6 January 2006

Reference: Recommended Technical Revisions to the Waste Discharge Requirements and Fact Sheet in the draft NPDES Permit¹ to be Reissued to the MBCSD²

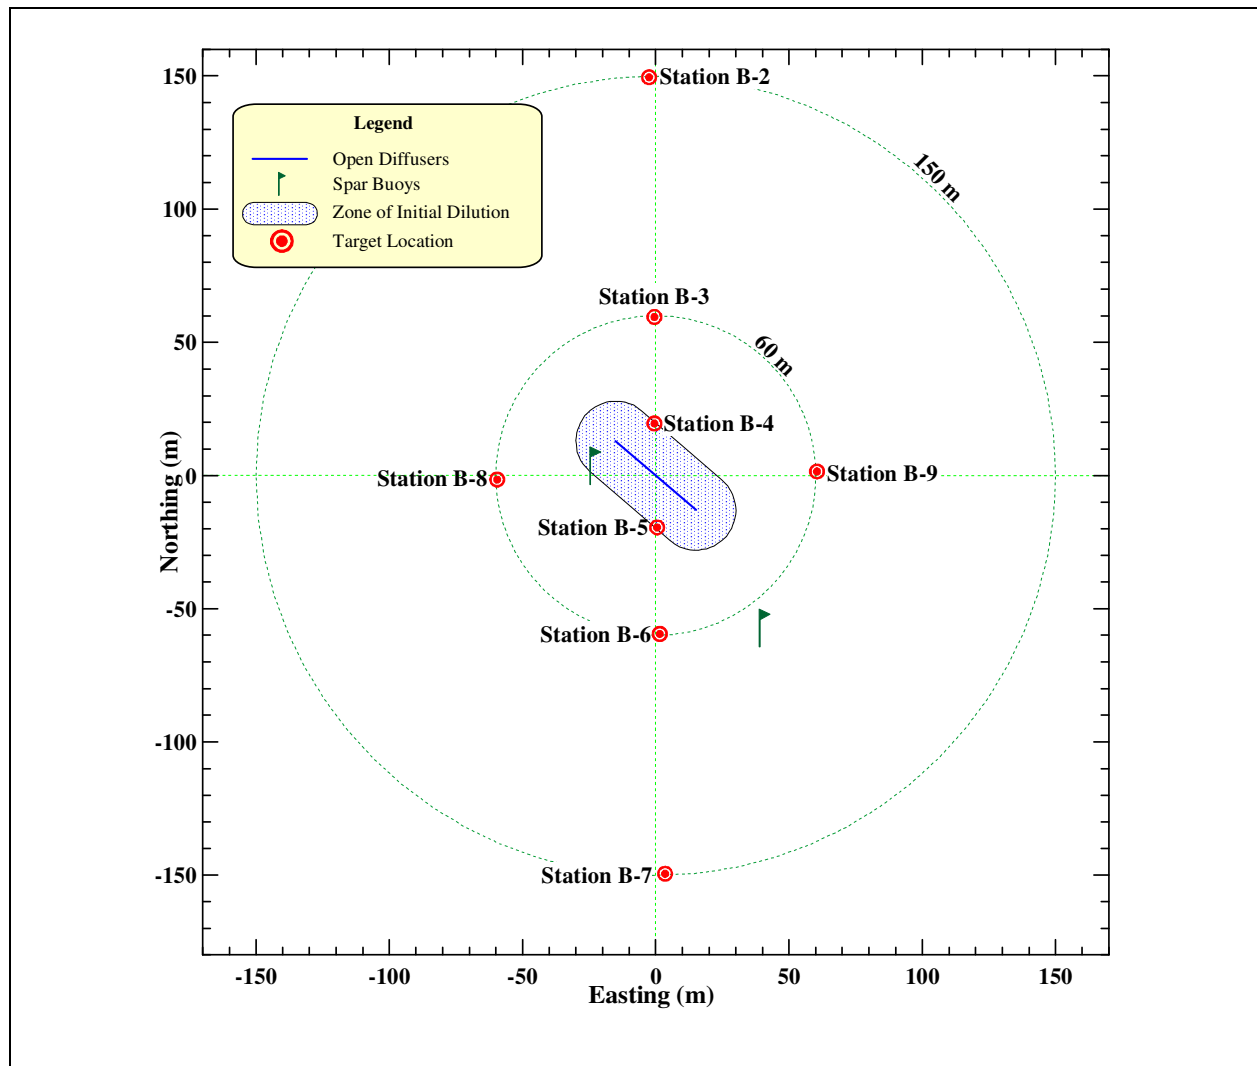
4. **Remove cross-shore benthic monitoring stations B-8 and B-9 [Page E-3, Section E.II] and add replicate sampling for composite chemical analyses at the remaining stations [Page E-14, Section E.VII.A].** The locations of cross-shore Stations B-8 and B-9 are shown in the figure on the next page.¹³ These stations were added in the last permit but were subsequently found to be heavily influenced by natural depth gradients. The depth-related differences at these stations mask potential discharge-related impacts and render the data at these stations of little use. In exchange for the reduced monitoring effort at these cross-shore stations, the grab sample replication should be increased at the remaining (along-shore) stations. Variability in trace-metal concentrations significantly increased after replicate grab sampling was dropped in the current permit’s monitoring program. Consequently, chemical analysis of a composite of three replicate grab samples at Stations B-2 through B-7 should be reinstated to stabilize the determination of chemical concentrations. To implement this requirement, the last sentence in the last paragraph on page E-14 should read: “~~A grab sample~~ Three grab samples shall be collected using a 0.1 m² Van Veen grab sampler at all benthic monitoring stations, and analyzed at each benthic monitoring station. A composite of these three samples should be analyzed as follows:”

¹³ The figure in the draft NPDES permit [Page E-3, Section E.II] does not show the location of Stations B-8 and B-9, although they are listed in the table of benthic monitoring locations.
